Clinton Power Station, Unit 1  
Facility Operating License No. NPF-62  
NRC Docket No. 50-461

Subject: Response to Request for Additional Information

Attachment A: Response to Request for Additional Information Related to Cold Shock at  
Clinton Power Station

Attachment B: Proposed Revision to Technical Specification Figure 3.1.7-1

Figure 3.1.7-1 (page 1 of 1)  
Weight Percent Sodium Pentaborate Solution  
Concentration/Net Tank Volume Requirements

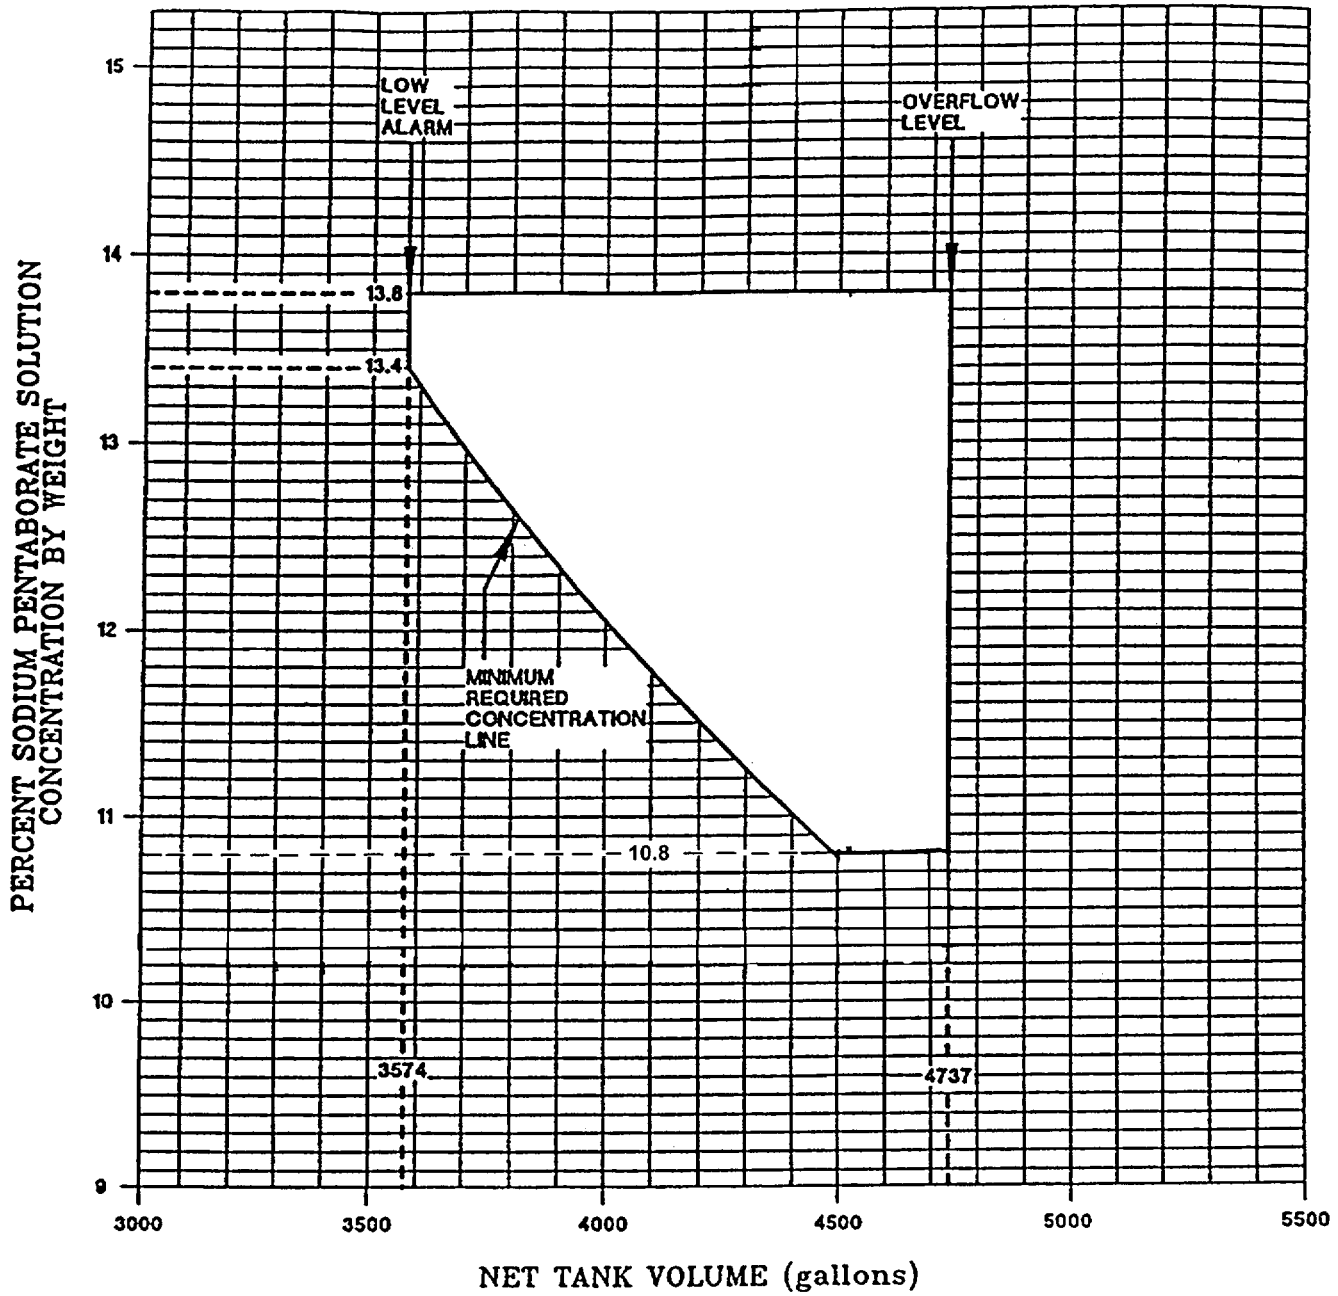
Reference 1 provided proposed markups to the Operating License and the Technical Specifications (TS). Included in the submittal was a proposed revision to TS Section 3.1.7 Figure 3.1.7-1. TS Figure 3.1.7-1 specifies the requirements for the "Weight Percent Sodium Pentaborate Solution Concentration / Net Tank Volume Requirements." The markup provided in Reference 1 was inadvertently revised to indicate the Standby Liquid Control tank high-level alarm setpoint. This alarm setpoint is not specified in the TS and it was not intended that this alarm point be added as part of this amendment. Therefore, a revised figure is provided in Attachment B to this letter as a replacement for the figure provided in Reference 1.

Proposed Revision to Technical Specification Figure 3.1.7-1
